ULNRC-05423

**DOCKET NUMBER 50-483
CALLAWAY PLANT UNIT 1
UNION ELECTRIC CO.
RESPONSES TO REQUESTS FOR ADDITIONAL INFORMATION
REGARDING REQUESTS FOR RELIEF FROM
ASME SECTION XI CODE EXAMINATION REQUIREMENTS
(INCLUDING WITHDRAWAL OF RELIEF REQUEST ISI-37)**

**REQUEST FOR ADDITIONAL INFORMATION
REGARDING RELIEF REQUEST ISI-34**

**REQUEST FOR ADDITIONAL INFORMATION
REGARDING RELIEF REQUEST ISI-40**

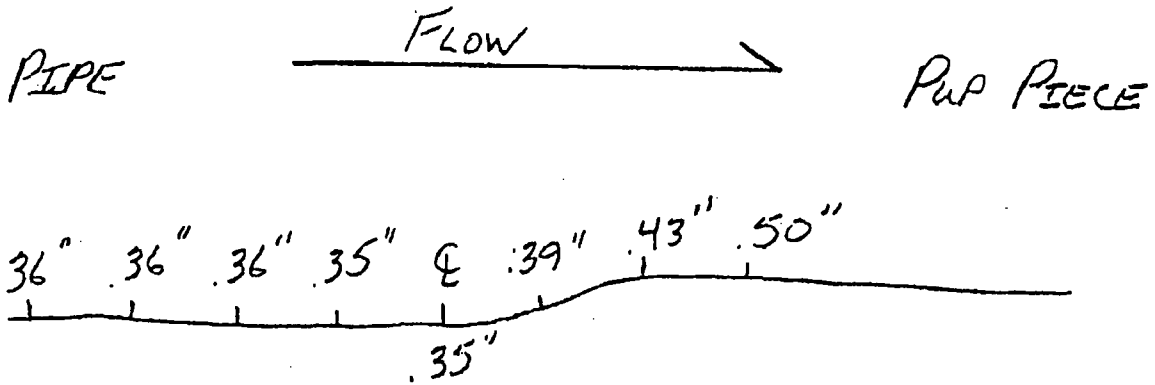
2. *The letter dated October 25, 2006, reduces the examination coverage for welds in the licensee's RI-ISI program. Discuss how the licensee's program will satisfy the minimum coverage criteria in the weld population that contributes to the percentage of the piping weld population referenced in TR-112657.*

As stated in the October 25, 2006 letter, "Using the degradation mechanism insight of Code Case N-711 and its associated white paper, Callaway Plant could take credit for examining 100% of the area of interest for the subject welds." The insights of Code Case N-711 were developed in the years following issuance and approval of TR-112657. The intent of the request for relief (ISI-34) was to incorporate those insights, ensuring that appropriate locations remain selected (i.e., welds with active degradation mechanisms) and that for each of the subject welds the appropriate required examination volume for the degradation mechanism is utilized and achieved as shown on figures "Coverage B1" and "Coverage B2."

Valve:

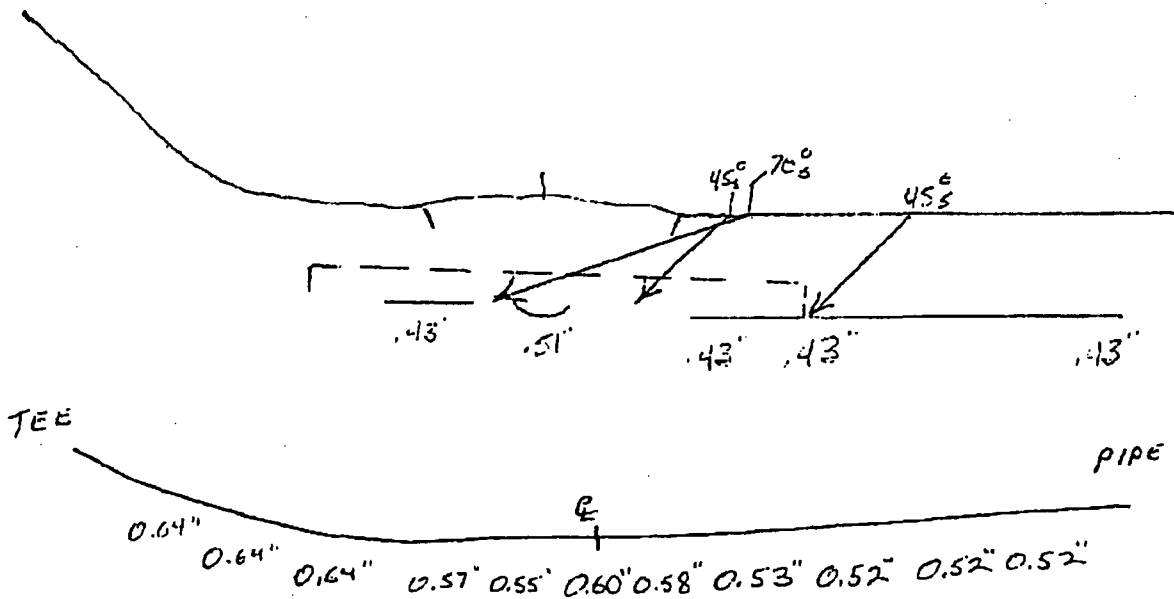
3. *The letter dated October 25, 2006 briefly listed the limitations for less than 100% coverage in the table titled "Description of Coverage Limitations." However, the table provided insufficient information to demonstrate impracticality. For each subject weld, provide a cross-sectional sketch identifying the material (carbon steel, cast or wrought stainless steel, cast or wrought nickel based alloys) in the weld region, identifying the wall thickness at the weld, and showing the interference location.*

All welds are stainless steel components to wrought stainless steel pipe welds.

The following sketches (shown on the next page), which are from the UT reports, are typical for the component welds in ISI-34

6" Pipe to Flange Weld

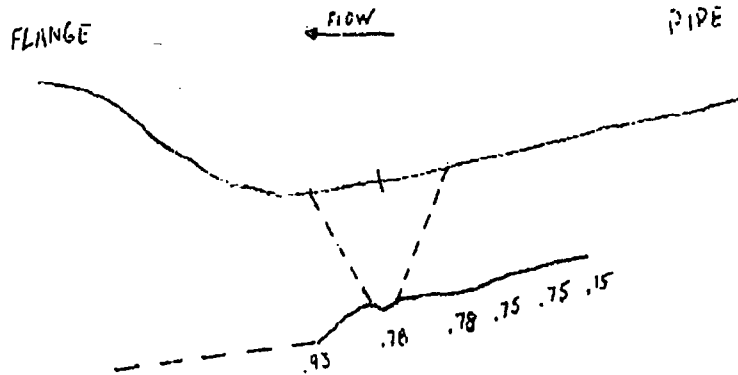
- 1. Provide a cross section sketch identifying the material (carbon steel, cast or wrought stainless steel, cast or wrought nickel based alloys) in the weld region, wall thickness at the weld, and describe or sketch the location and type of interference for each weld.*

Comments: Weld Profile and Scan Limitation

Scan limited to one side only due to flange, examination volume considered 50% complete in accordance with APP. VIII requirements. Best effort examination performed on the flange side using refracted L wave.
Reference UT Report #'s UT-05-041, UT-05-042, UT-05-043.
